TRANSMITTAL COVER SHEET

DATE: 21 June, 2024
TO: ALL PLAN HOLDERS OF RECORD
FROM: HUNTER SWATEK, AIA, PROJECT MANAGER
PROJECT: RAINBOW CITY RECREATION CENTER
GMC PROJECT NO. ABHM230021
RE: ADDENDUM NO. 3 AND
ACKNOWLEDGEMENT OF RECEIPT OF ADDENDUM NO. 3

ADDENDUM NUMBER 03

**PROJECT: RAINBOW CITY RECREATION CENTER
GM&C PROJECT NO. ABHM230021**

11 CONCRETE SEAT WALL
1" = 1'-0"

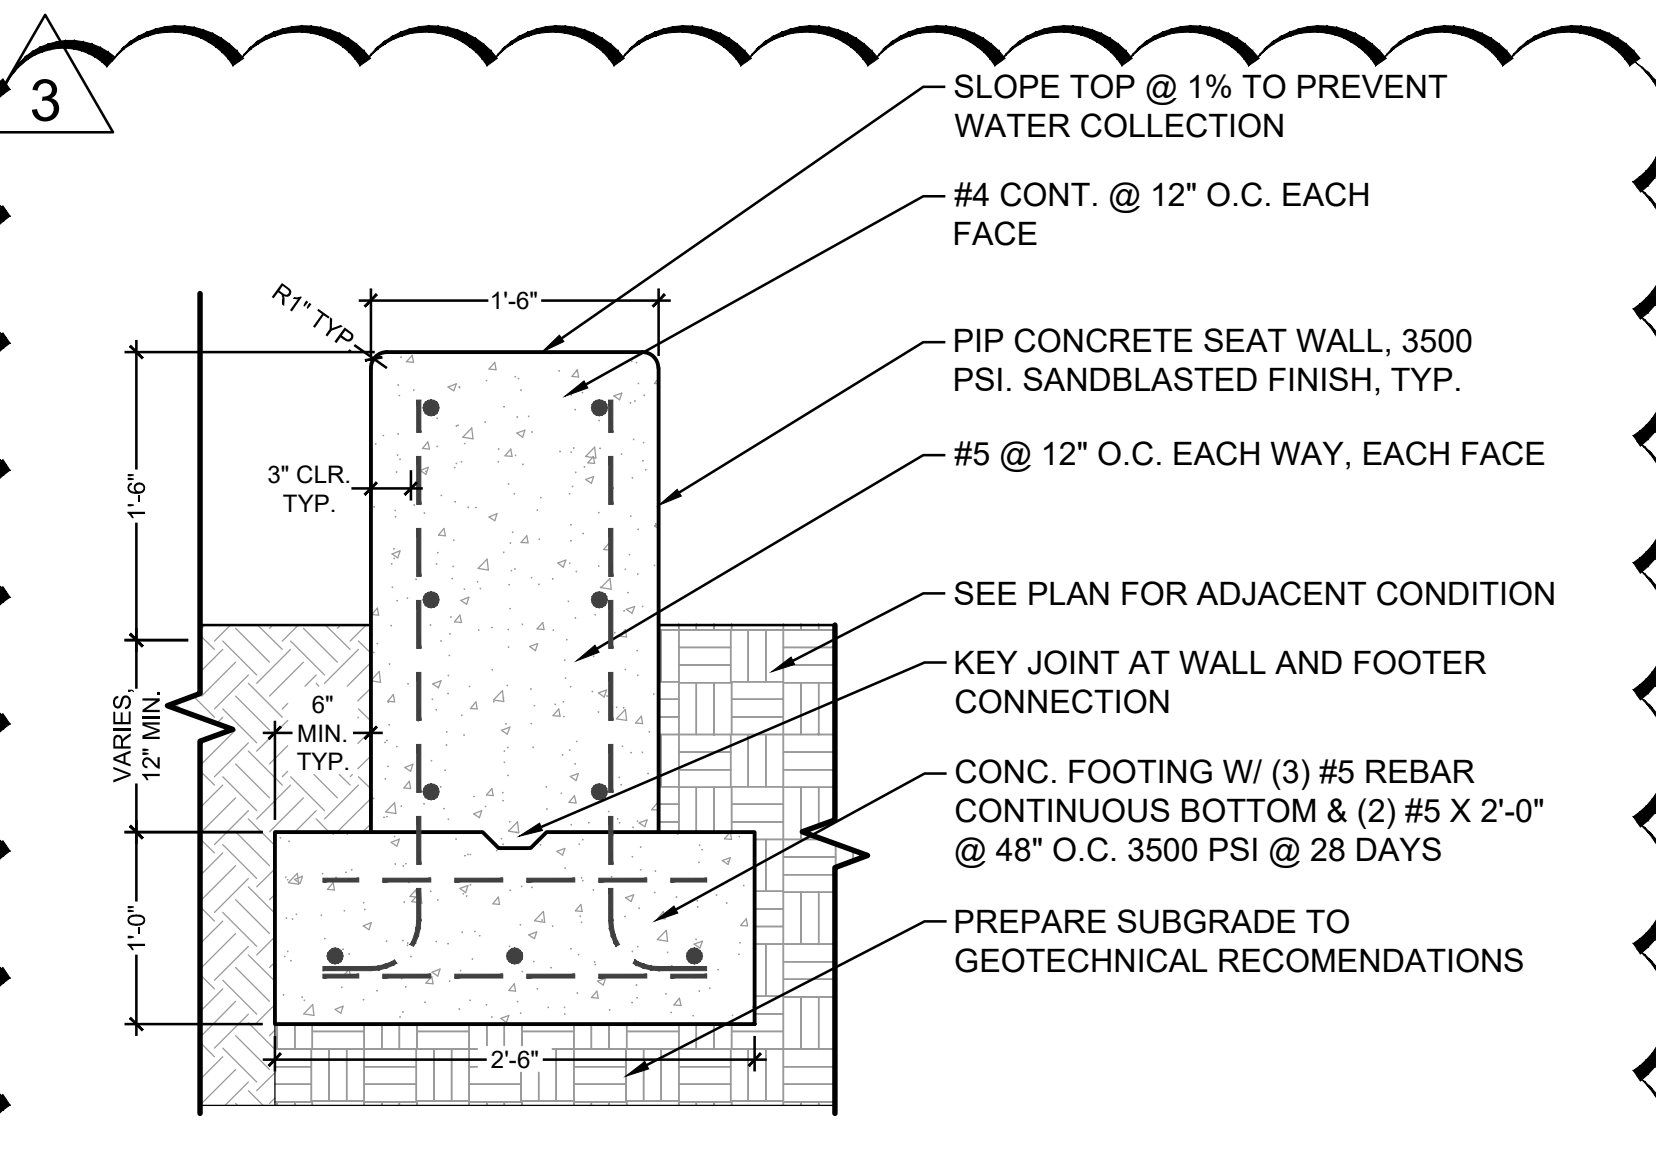
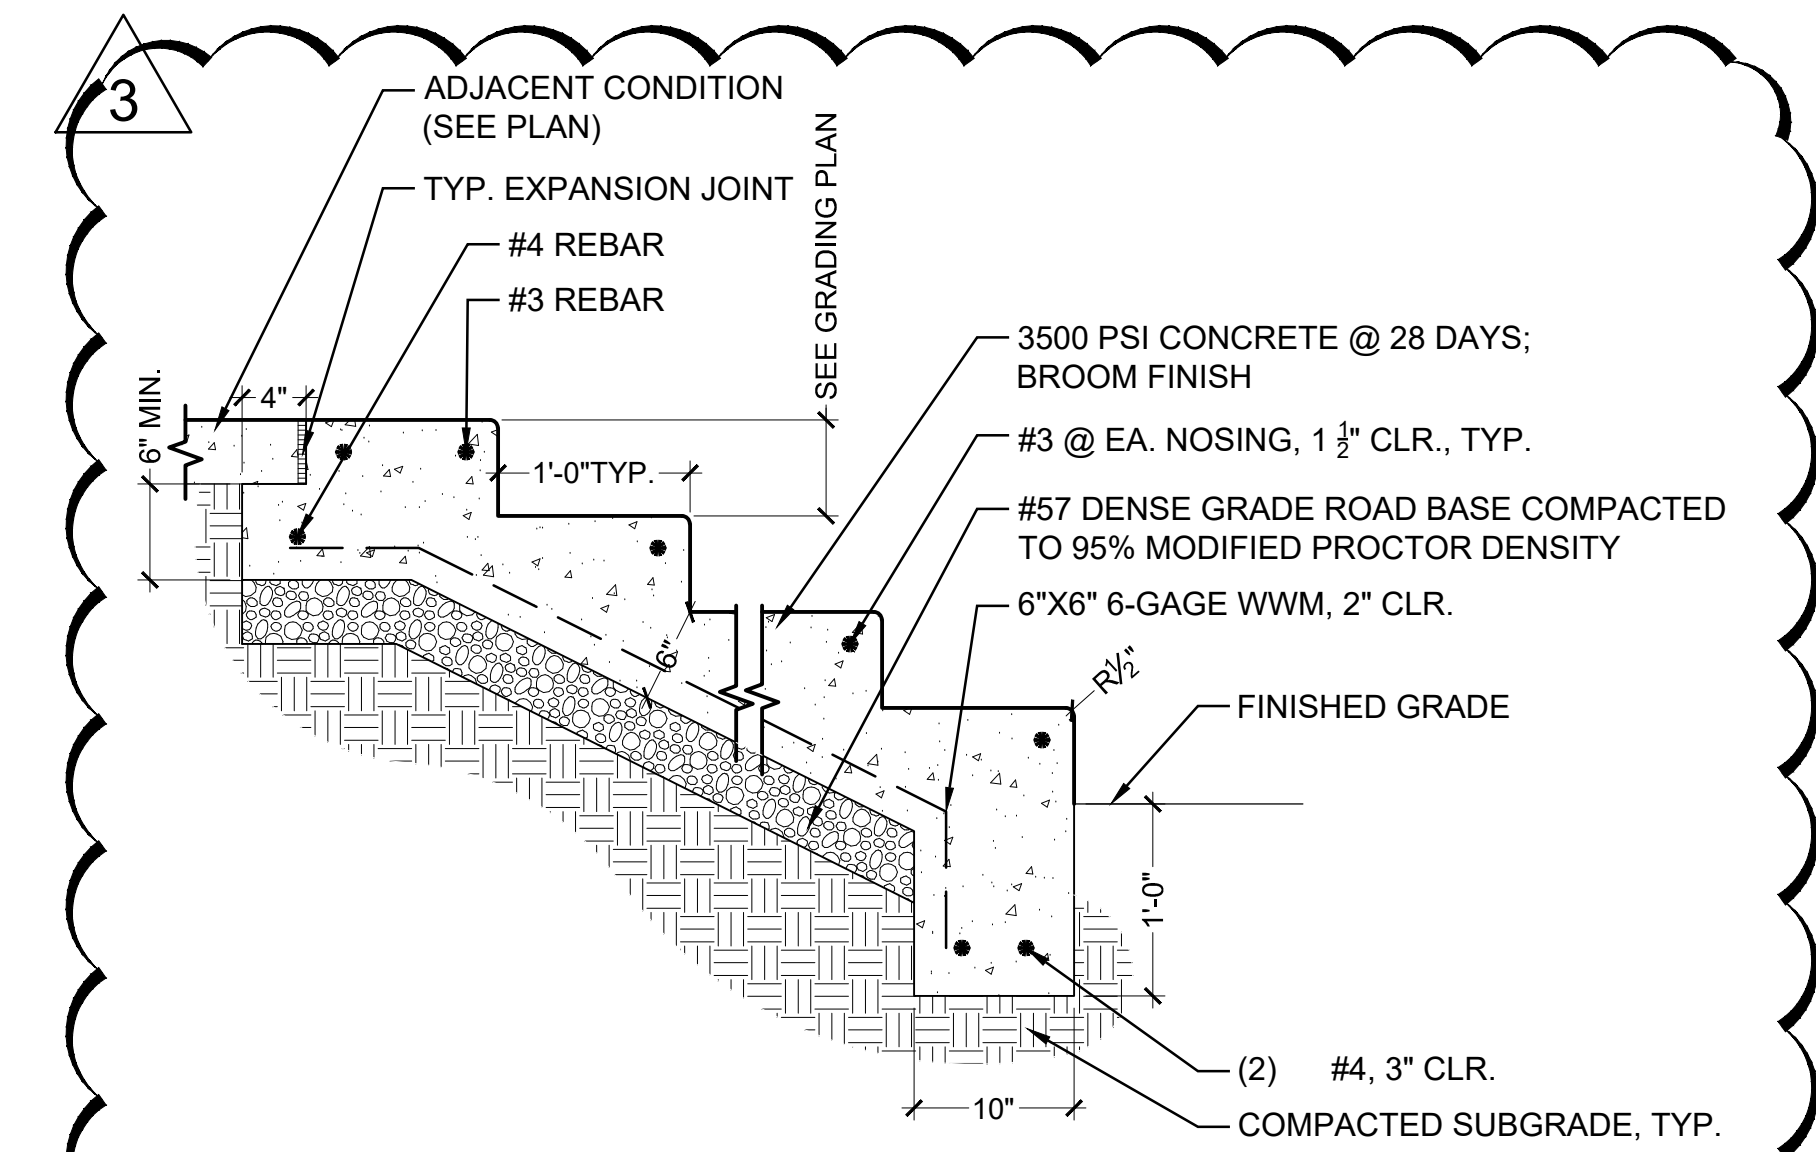
- O. **L1.01** – Materials Plan: Base
 - a. REVISED Notes
- P. **L1.02** – Materials Plan: Alternate
 - a. REVISED Notes
- Q. **L4.01** – Hardscape Details

- a. ADDED Details
- R. **S1.01** – Joist Loading Diagrams
 - a. REVISED Loads
- S. **S1.08** – Joist Loading Diagrams
 - a. REVISED Loads
- T. **S2.01** – Floor and Foundation Plan

5	Per the prebid, clarify that although the project is tax exempt, bidders are to include an occupational tax of 2%	1	Yes
6	Please provide the total R value of the roof insulation	1	Provide minimum R-25 c.i
7	There seems to be some discrepancy in the intent of alternates 2 and 3 between the Alternates spec, the Bid Form / Tax Form, and the drawings. Are these supposed to be additive alternates or deductive alternates? Please provide more info and clarification on these alts	3	See revised Alternates section and Civil drawings
8	Sheet L1.01 references Arch dwgs for outdoor showers, but cannot seem to locate on arch drawings. Provide spec/detail if to be included by GC in base bid or alt 2	3	Outdoor showers will be included in base bid. Shower location can be found on updated sheet L1.01. Refer to Addendum 02 Plumbing for piping information.
9	Provide detail for seat walls shown at brick paver areas and amphitheater area	3	See attached - L4.01

10	Provide subslab / subgrade prep requirements for brick pavers	3	See attached - L4.01
11	Provide spec for WDP-1 Parklex Wood Paneling	3	See Attached - Addendum 03

23	Is the WDF-1 condition the same as spec section 096466 Wood Athletic Flooring Assemblies? WDF-1 is not included in Finish Legend.	2	WDF - 1 is meant to be WFS - 1, WFS - 1 is referenced in the finish legend
24	On signage type details on A8.51, it shows types A1, A8, & A10. However, there are none of these shown on signage schedule on A8.52. Please clarify if these are included & their quantities & locations.	2	Correct, A1, A8, and A10 are not included in the project
25	Please provide details for the stairs for the amphitheater. Either the landscape or civil plans provide details for the stairs.	3	See attached - L4.01
